***EXPEDITED***  
**MONTGOMERY COUNTY HISTORIC PRESERVATION COMMISSION**  
**STAFF REPORT**

<b>Address:</b>	11900 Darnestown Road, Gaithersburg	<b>Meeting Date:</b>	6/24/2020
<b>Resource:</b>	Master Plan Site #24/13 ( <i>Quince Orchard Colored School</i> )	<b>Report Date:</b>	6/17/2020
<b>Applicant:</b>	Pleasant View Historic Association ( <b>Thomas Taltavull, Architect</b> )	<b>Public Notice:</b>	6/10/2020
<b>Review:</b>	HAWP	<b>Tax Credit:</b>	Partial
<b>Case Number:</b>	24/13-20A	<b>Staff:</b>	Michael Kyne
<b>PROPOSAL:</b>	Building addition and renovations

Re: Pleasant View M.E. Church and Quince Orchard Colored School, Montgomery County  
Pending Easement  
Maryland Historical Trust Preservation Easement  
Loan of 2017, Chapter 22

PROPOSED ELEVATIONS

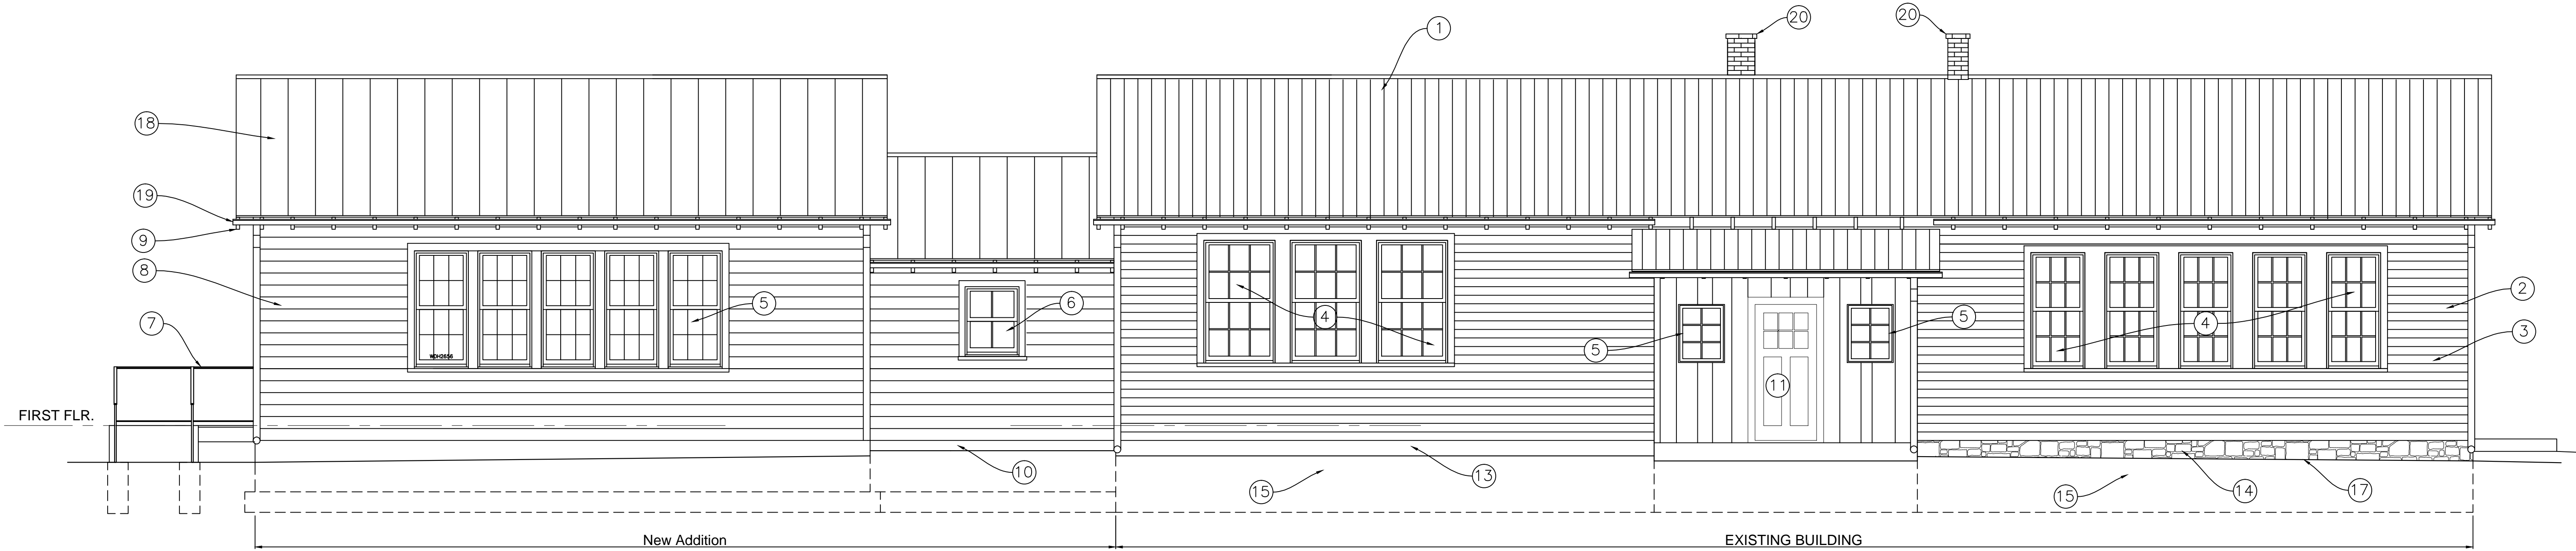
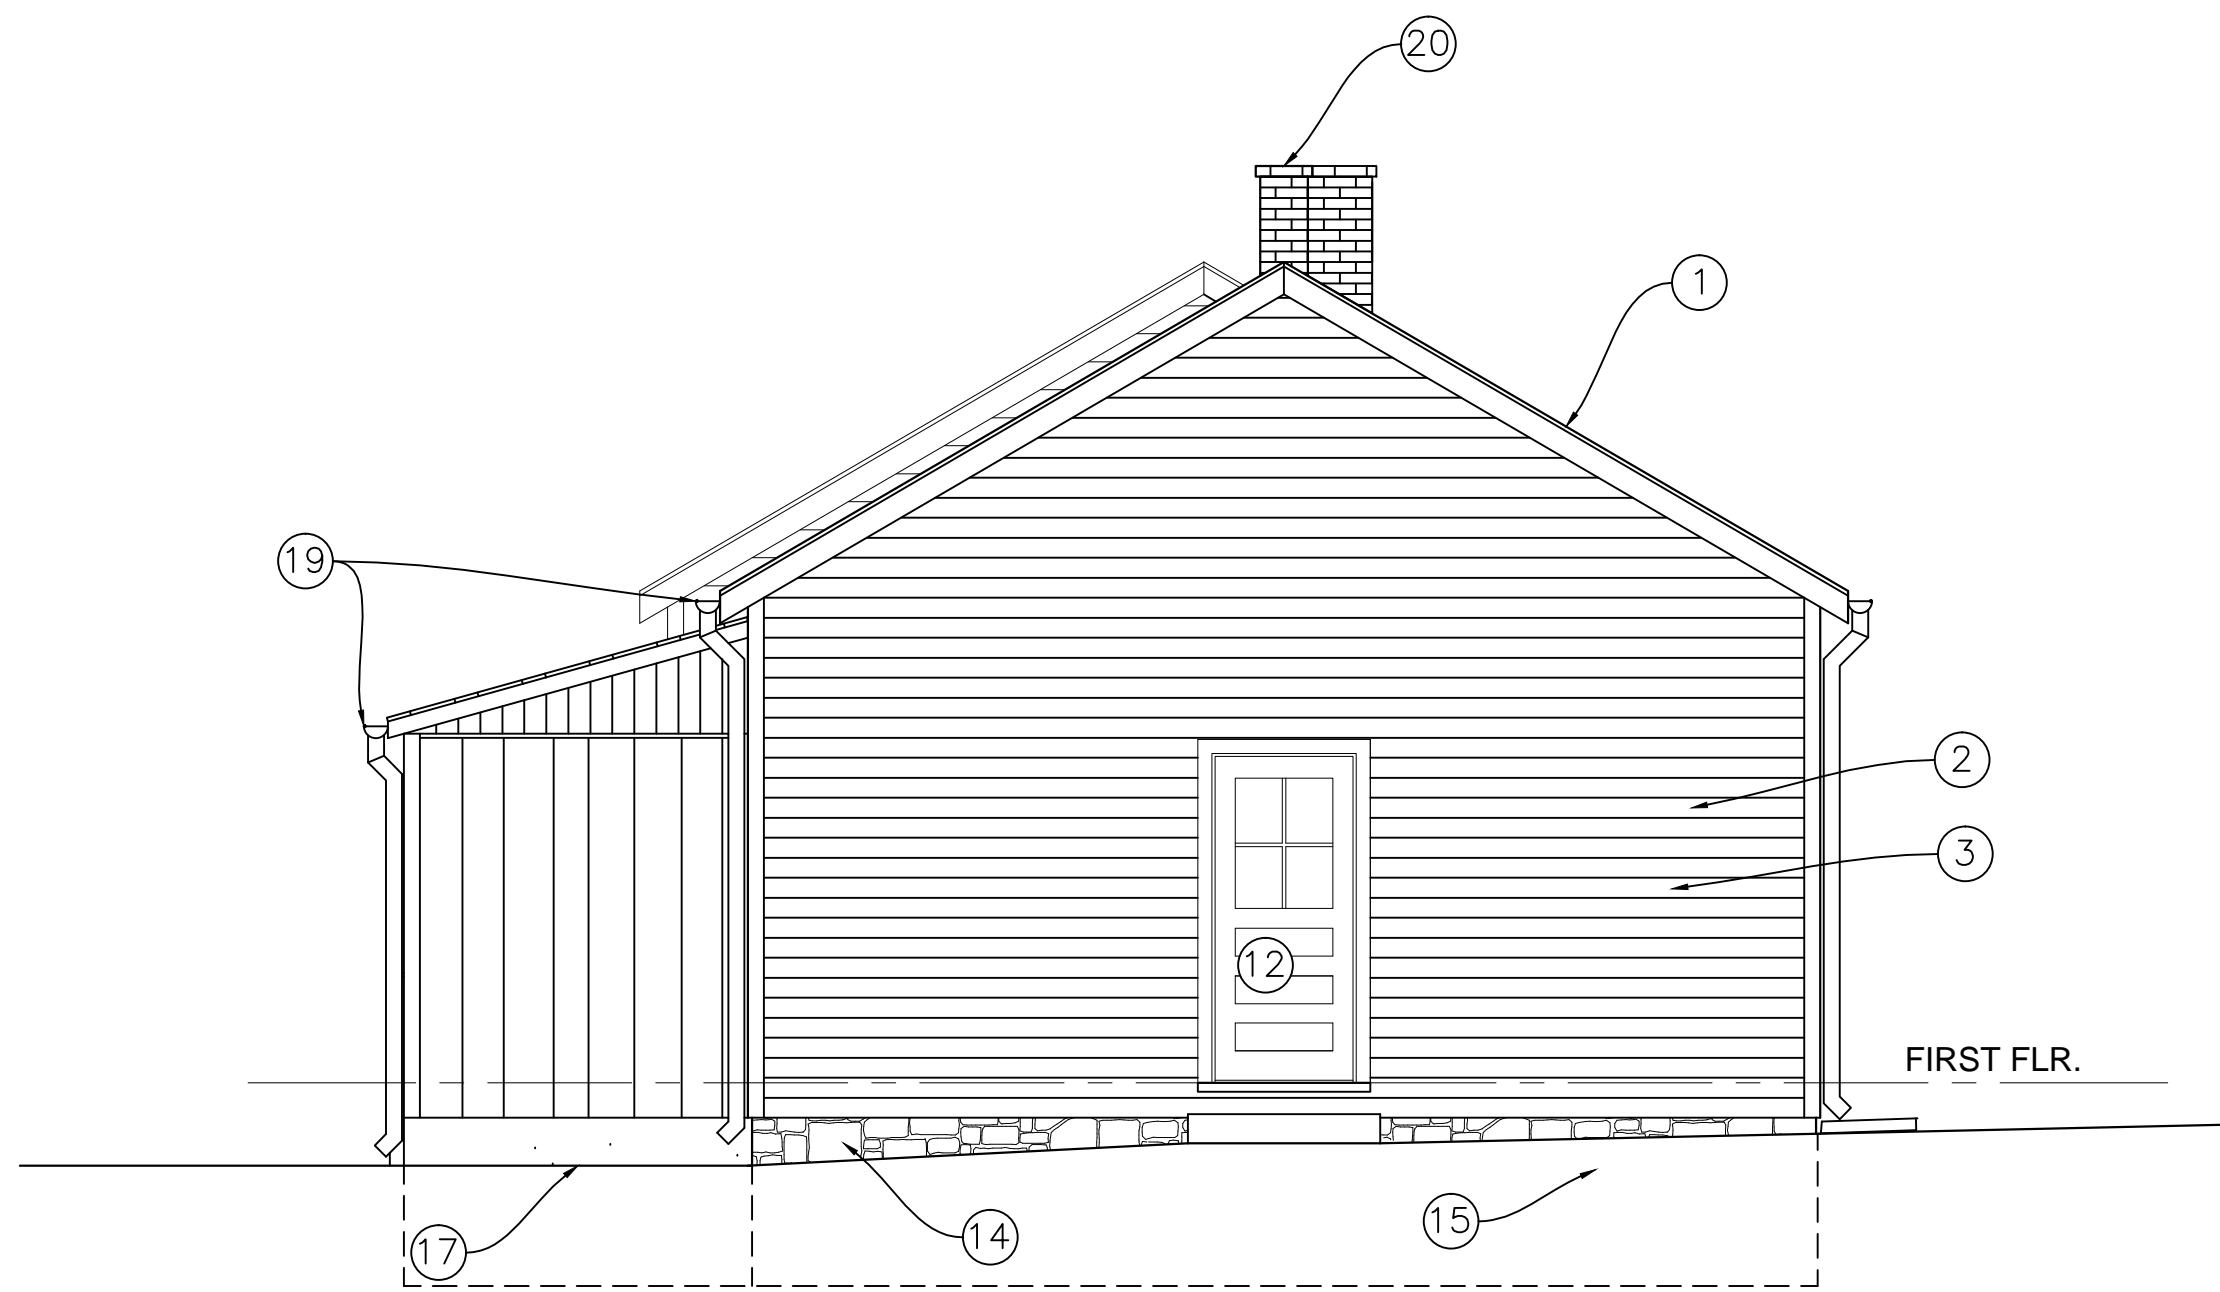
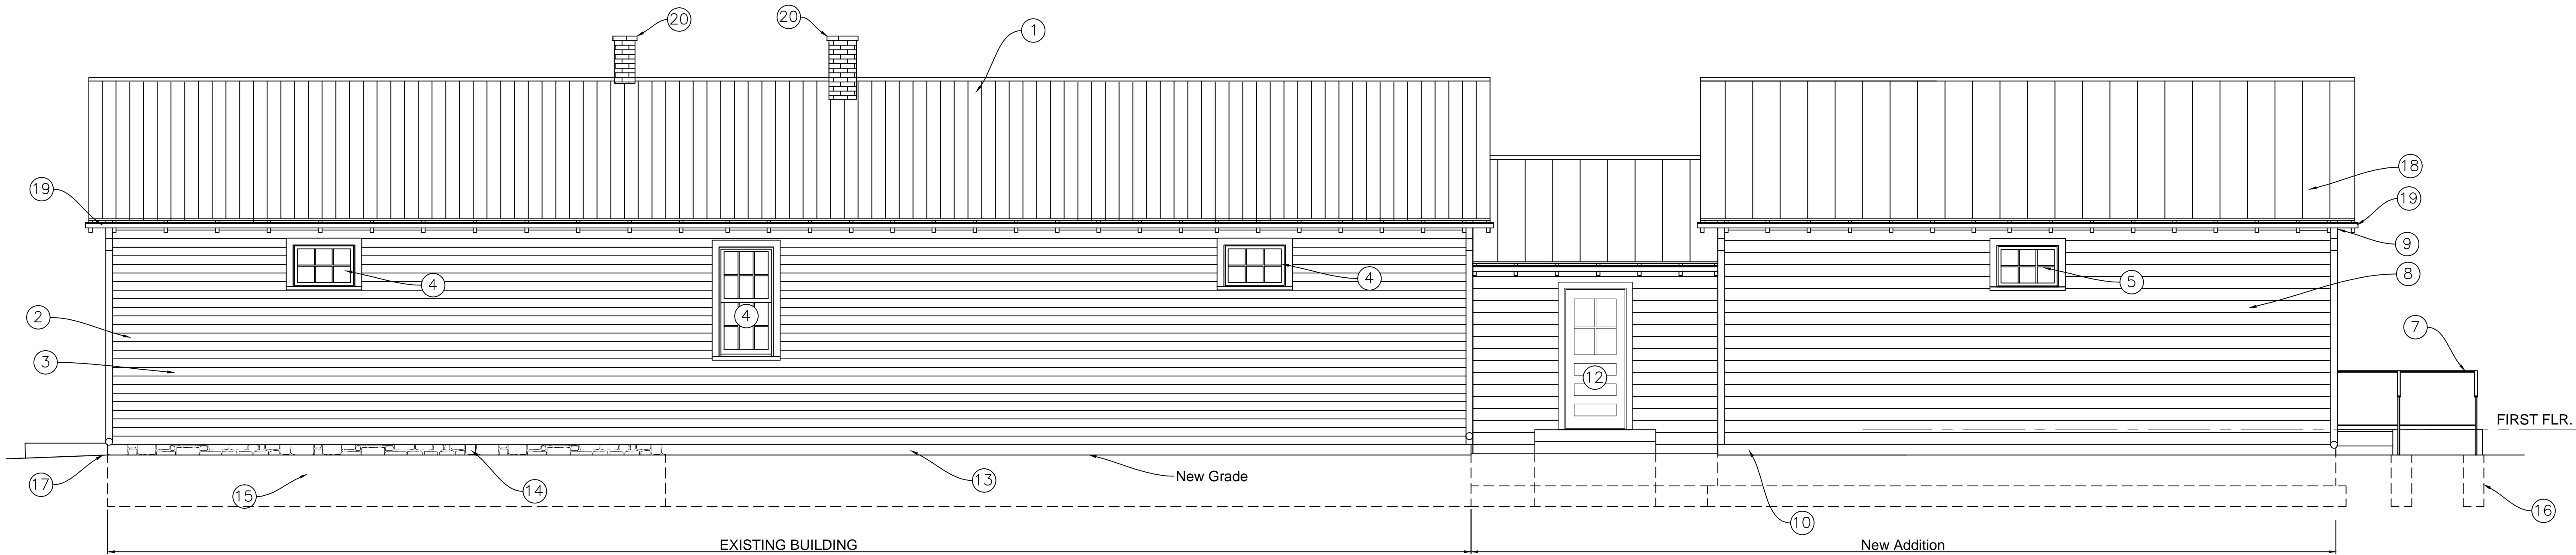
- A mock-up of the new field stone foundation wall be undertaken to ensure that the reconstructed wall matches in-kind. Once the mock-up has been completed, photographs should be submitted for review and approval.

CONTRACTOR NOTE:  
1. A MOCK UP OF THE REBUILT FIELD STONE FOUNDATION WALL TO BE REVIEWED AND APPROVED BY OWNER AND THE MARYLAND HISTORICAL TRUST.
